# MONITORING YEAR 0 ANNUAL REPORT FINAL

## Liberty Rock Mitigation Site

Subject: DMS Comments on Liberty Rock Mitigation Site Monitoring Year 0 Report  
DMS Project Number 100135  
Randolph County, North Carolina  
Contract No. 7877-01

**Rocky River Reach 1 (STA 101+24 to 106+00)**

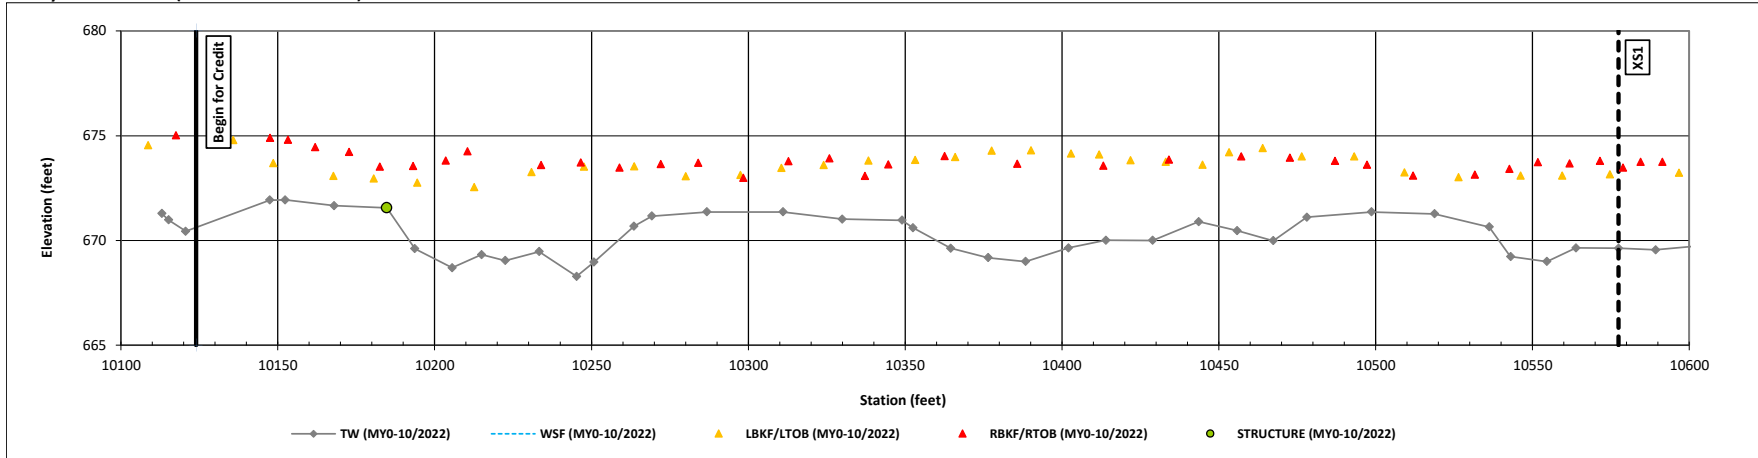
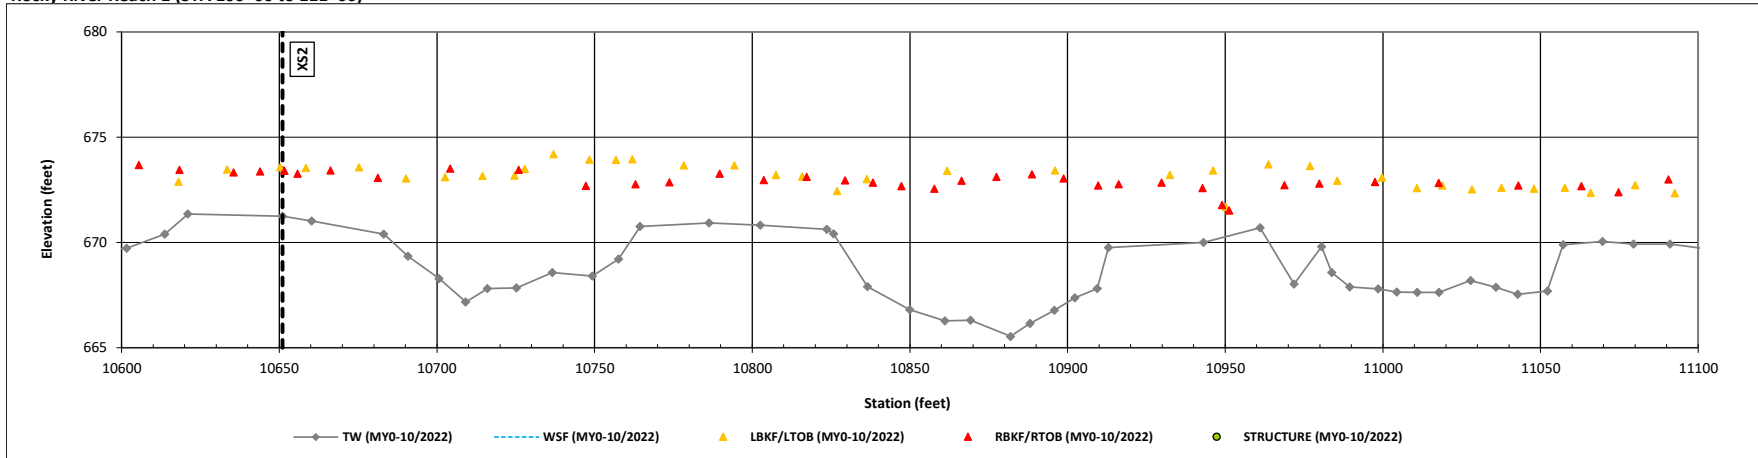
3. Should Water Surface (WSF) be shown on the Rocky River Reach 1 longitudinal profile?

*No water was present in the stream channel at the time of the as-built survey; therefore, no water surface is shown on the profile. This has been denoted on the Rocky River Reach 1 profile plots.*

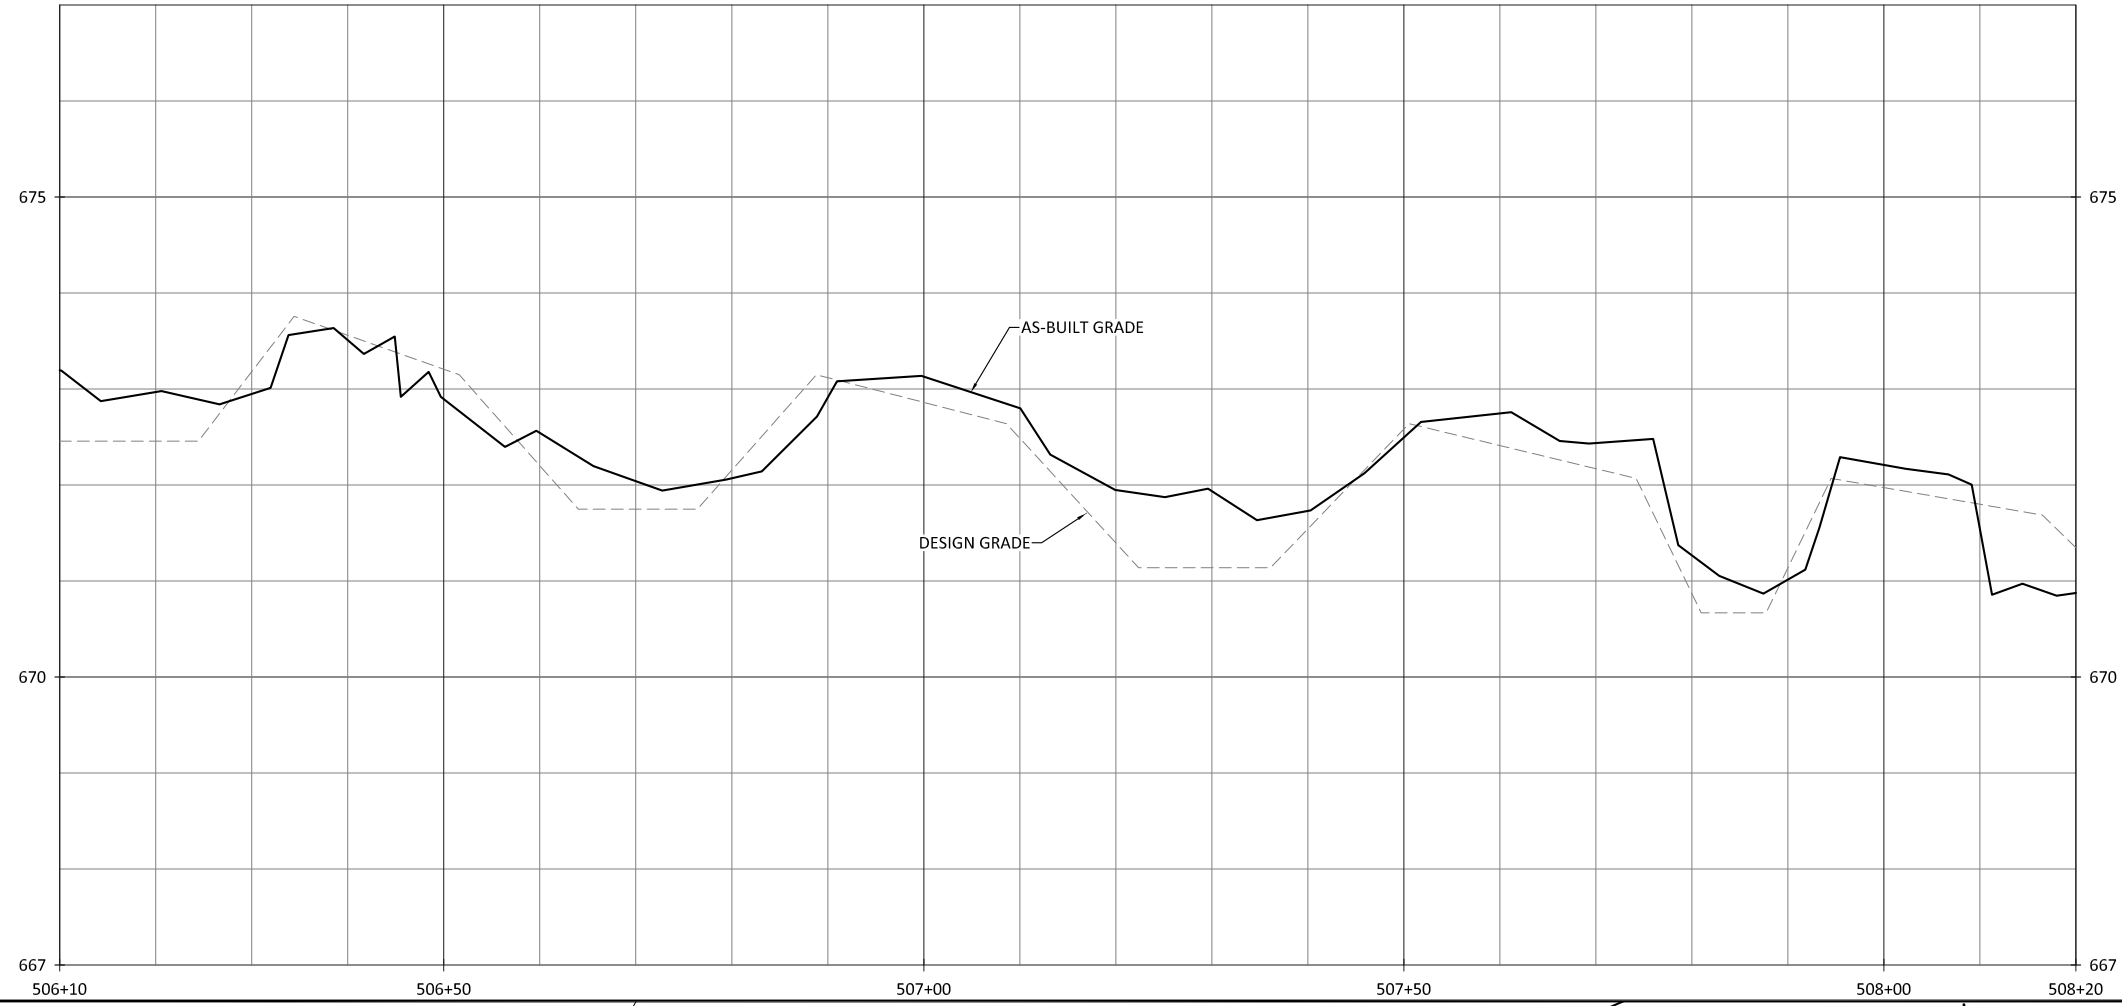
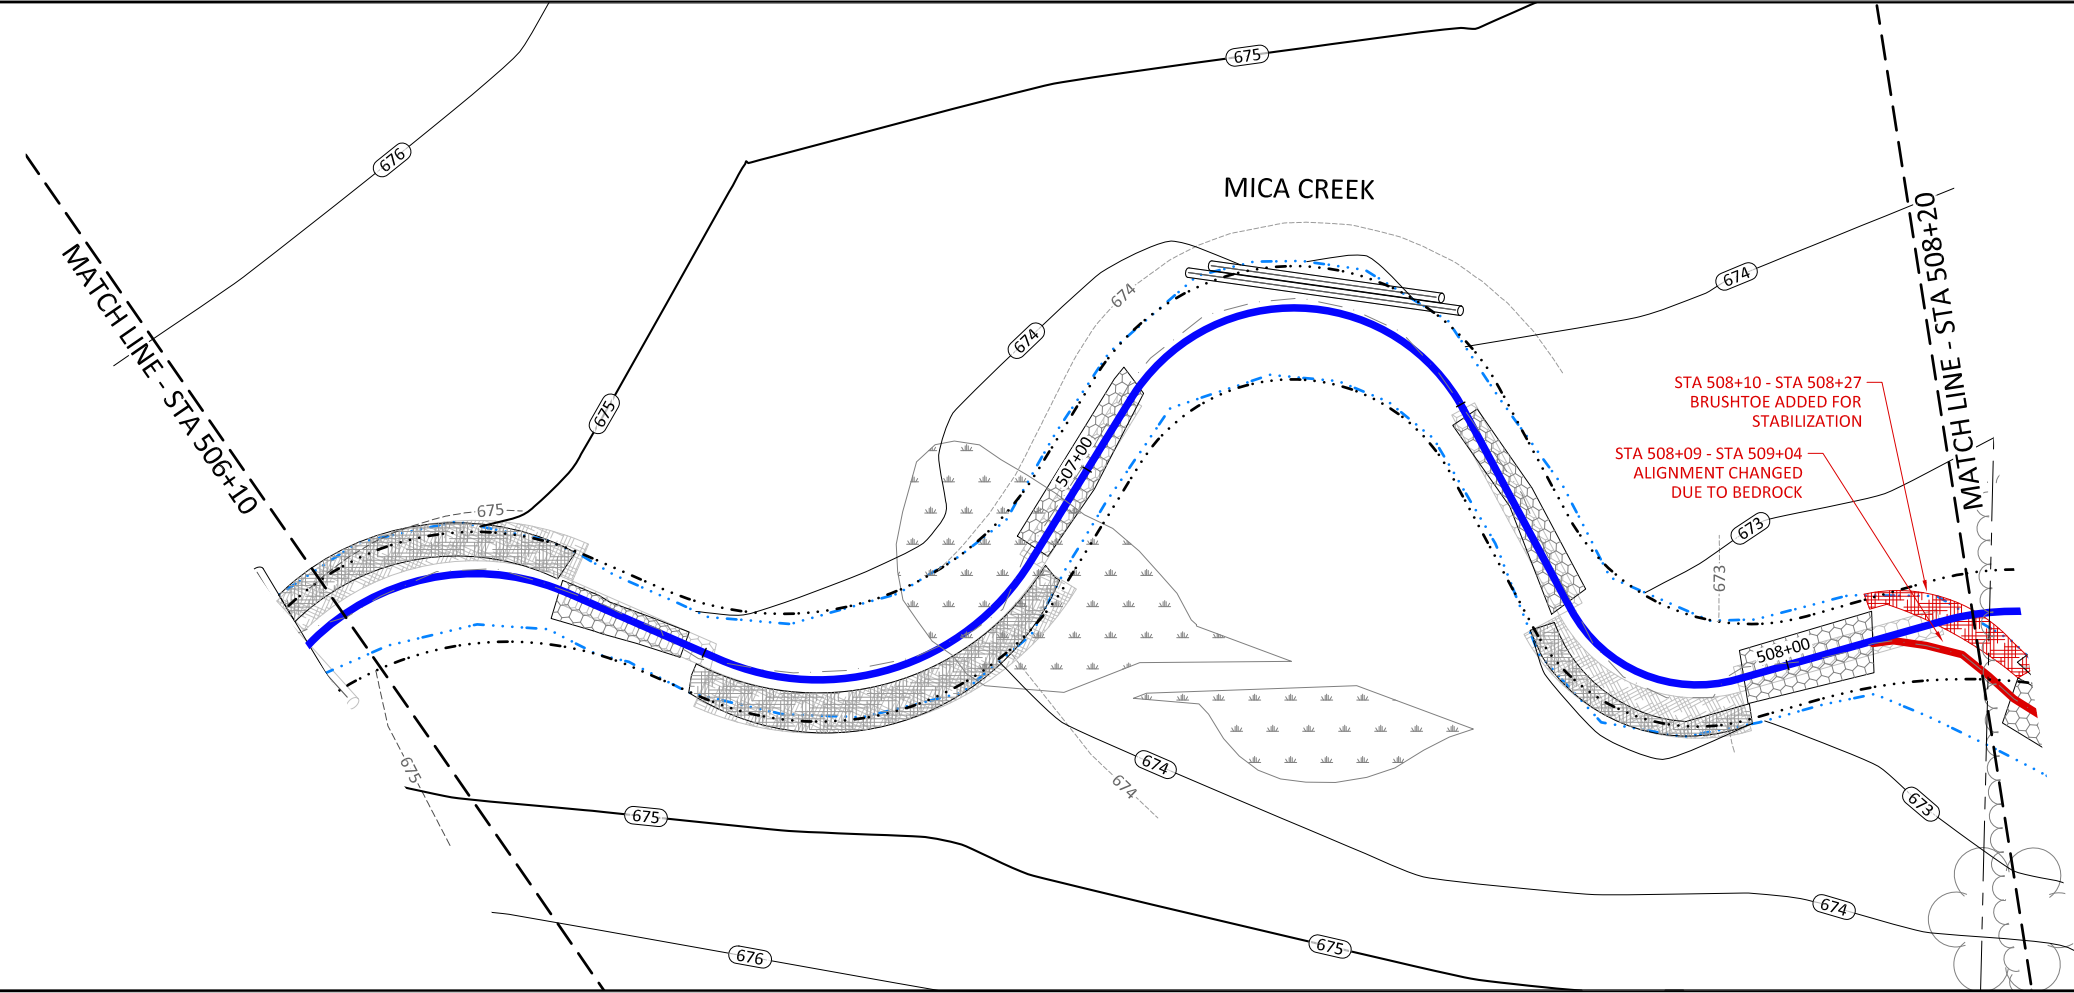
4. Sheet 1.13 – A log sill is shown near PP14 that is not shown in the approved mitigation plan drawings, and is not colored red to indicate a construction adjustment. Please correct.

*The structure shown is included in an existing angled log riffle shown and approved in the mitigation plan drawings; the additional symbology has been removed to maintain consistency.*

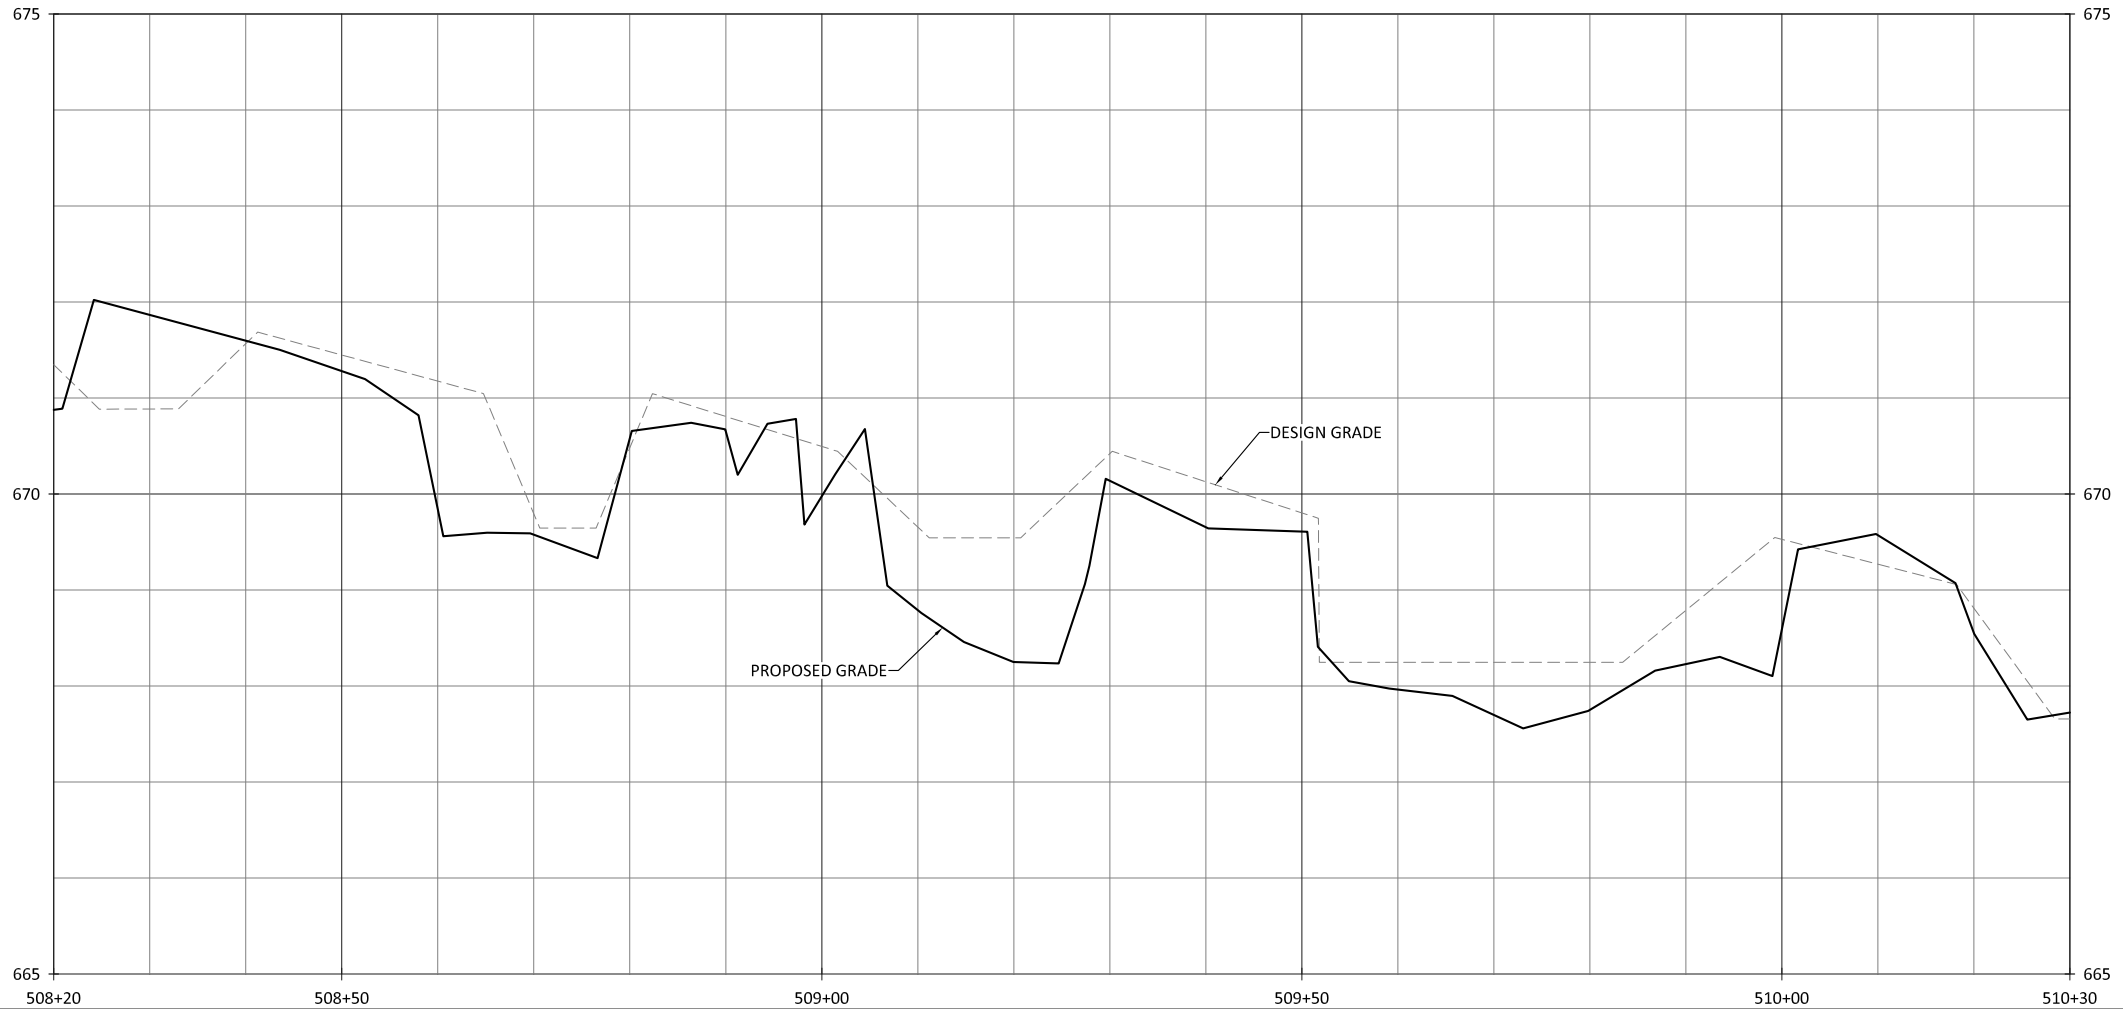
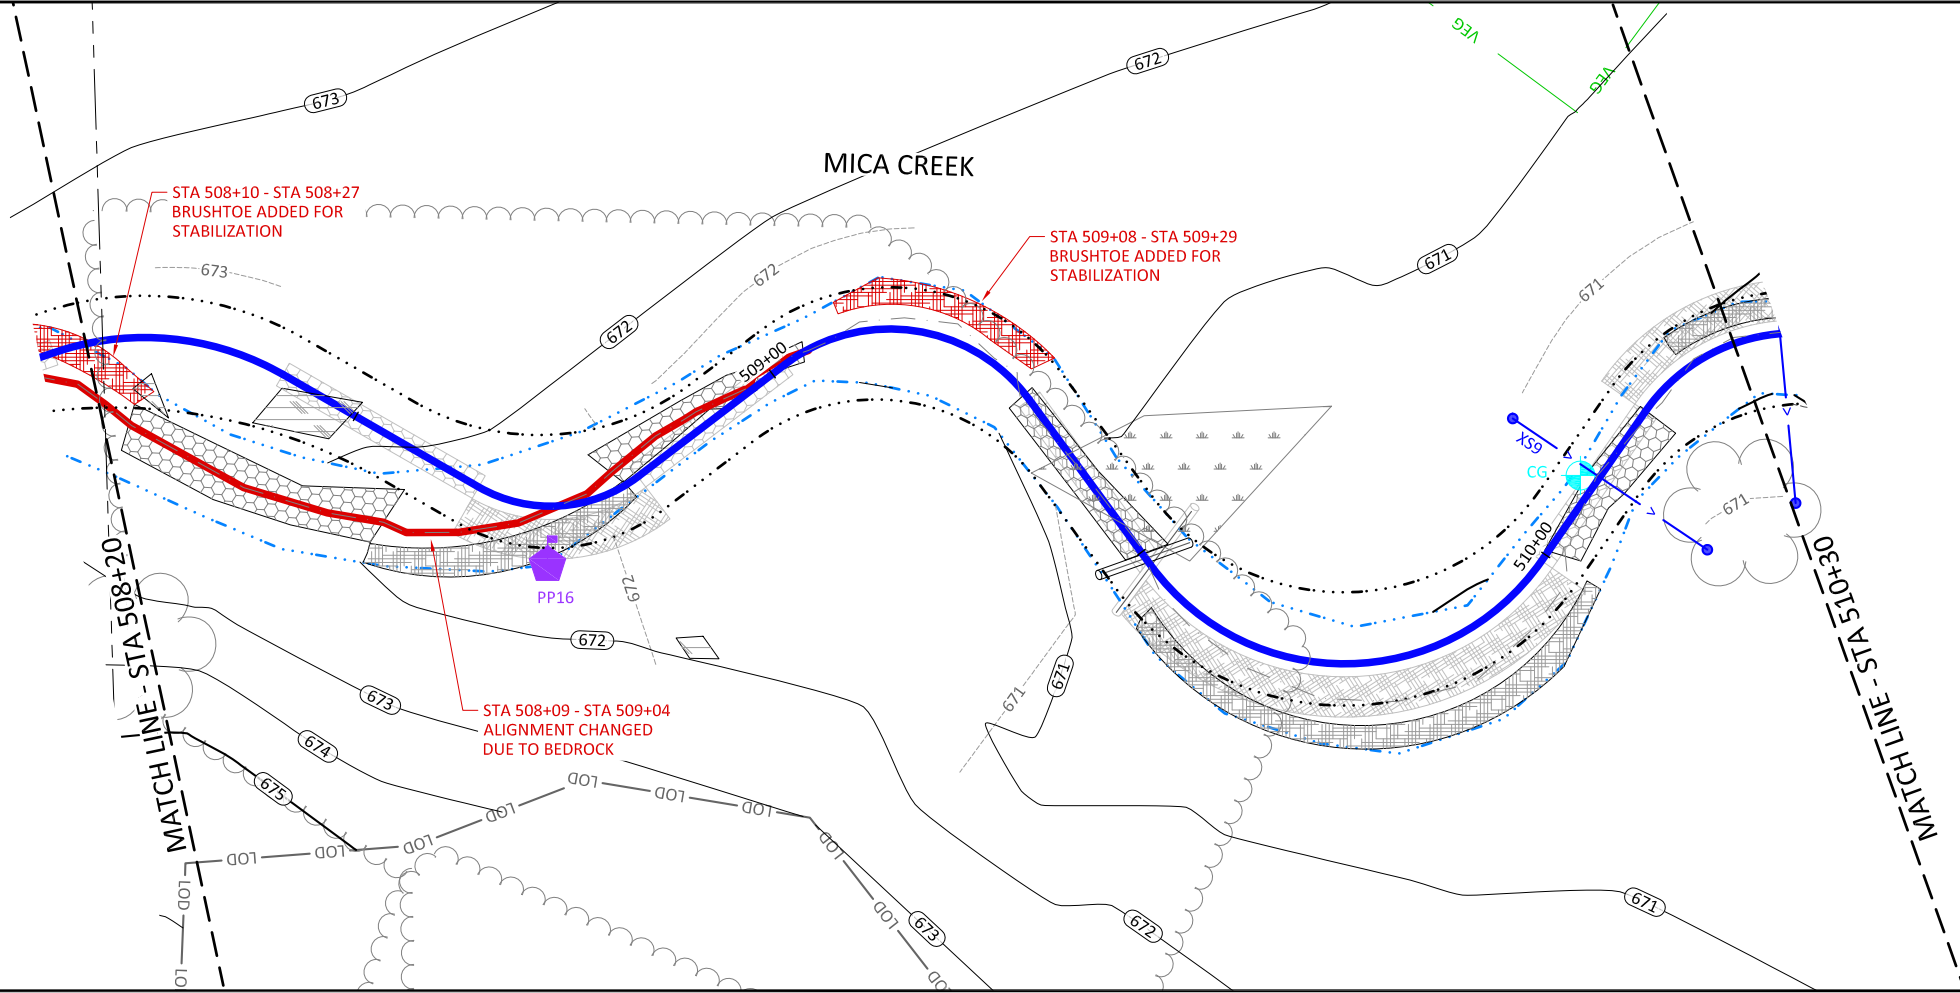
5. Sheet 1.15 – Similar to comment above. A log sill is shown on the first riffle (~506+50) that is not shown on the mit plan drawings, and is not colored red.

6. Sheet 1.15 & 1.16 – It appears that the brush toe installed at 508+09 due to the channel alignment deviation should be colored red.

*The structure shown is included in an existing angled log riffle shown and approved in the mitigation plan drawings; the additional symbology has been removed to maintain consistency.*

*The brush toe installed at 508+09 due to channel alignment deviation has been noted and colored red.*
